Minutes of 101st PCC Meeting

MINUTES OF 101ST PROTECTION SUB-COMMITTEE MEETING HELD ON 13.04.2021 AT 10:30 HOURS

ITEM NO. B.1: Total Power failure at 220 kV Lalmatia and Godda S/S on 22.03.2021 at 11:05 hrs

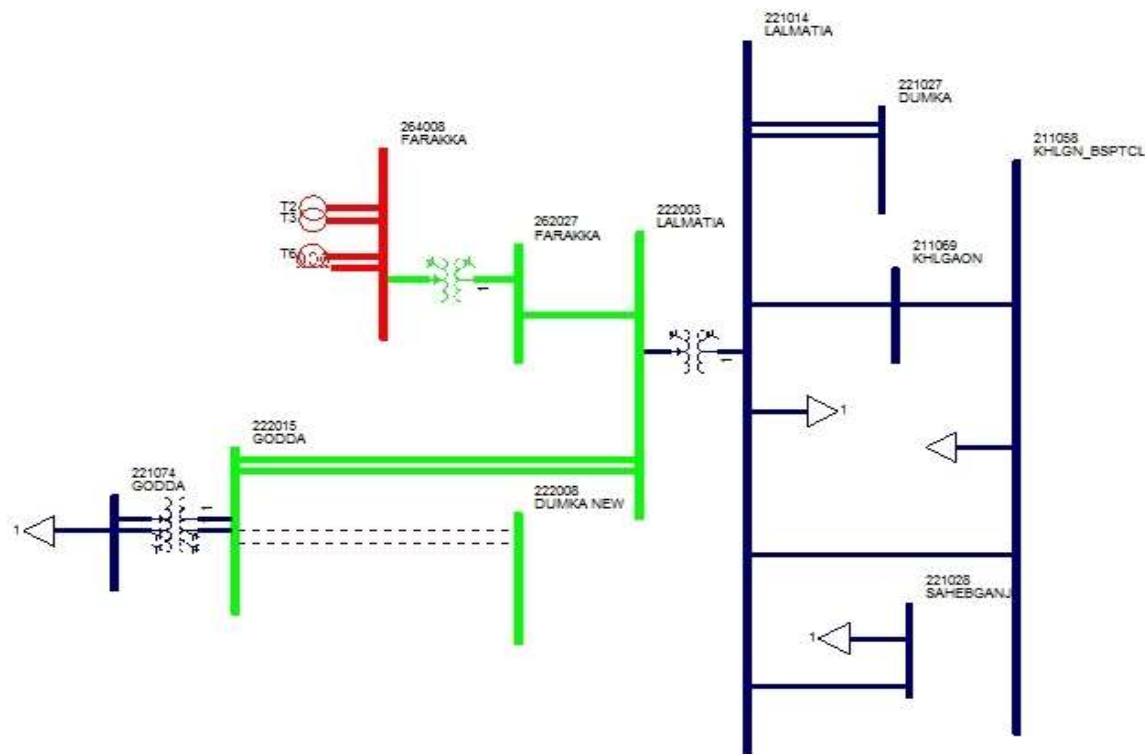
From relay indications it was observed that there was no fault in 132kV KHSTPP-Lalmatia line. 132kV KHSTPP-Lalmatia tripped on Z3 from KHSTPP end due to non-tripping of breaker of 220kV FSTPP-Lalmatia at Lalmatia end.

PCC observed that as no protection system operated at 220 kV Lalmatia end, the fault should have been cleared by the 220/132 kV ICT at Lalmatia S/s. The tripping of 132 kV KhSTPP-Lalmatia line is not in order. PCC observed that there is a coordination issue between the 220 /132 kV ICT and zone-3 settings of 132 kV KhSTPP-Lalmatia line at KhSTPP end and advised JUSNL & NTPC to properly coordinate the relay settings at their respective end.

PCC also advised JUSNL to enable directional high-set in backup overcurrent relay at LV side of 220/132 kV ICT at Lalmatia for faster fault clearance in case of non-clearance of fault in 220 kV Farakka-Lalmatia line at 220 kV Lalmatia end.

Figure 1: Step 1 fault calculation 1

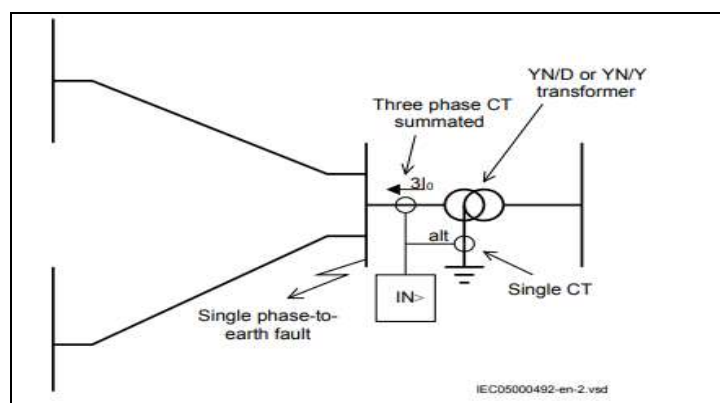
- A. The primary requirement for the stage 1 setting should be to detect earth faults at the local bus bar, where the transformer winding is connected. Therefore, a fault calculation should be made as per figure 1. This calculation provides the current fed to the protection i.e. $3I_{0\text{fault1}}$. To assure that step 1 calculation to have selectivity for other earth-fault protection in the network, a short delay may be selected. Normally, a delay in the range of 0.3 – 0.4 s is appropriate under such conditions.

Figure 2: Step 1 fault calculation 1

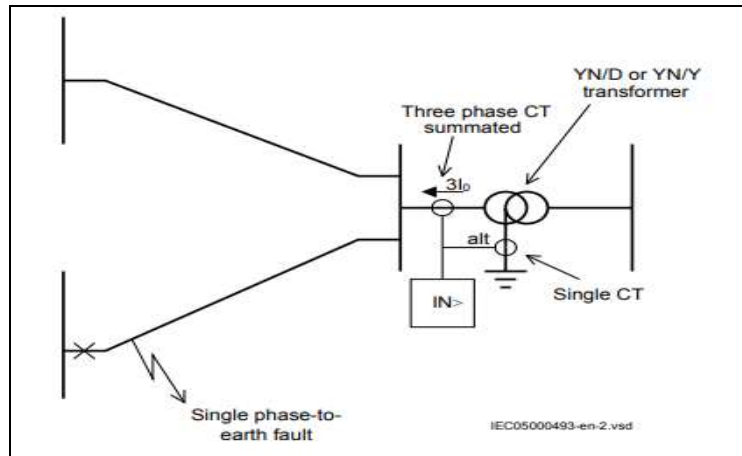
Further to ensure selectivity to delayed line faults clearance at the local bus (typically distance protection operation in zone 2 in 0.5 sec), the current setting must be set high enough so that these faults do not result in unwanted step 1 trip of transformer on earth fault stage 1 setting.

Therefore, a fault calculation as shown in figure 2 is also required to be done. If the fault is located at the borderline between the instantaneous and delayed operation of the line protection (such as Distance protection or line residual overcurrent protection), the above calculation gives the current fed to the protection i.e. $3I_{0\text{fault}2}$ the setting of step 1 can be chosen within the interval shown relation given below for the above calculations.
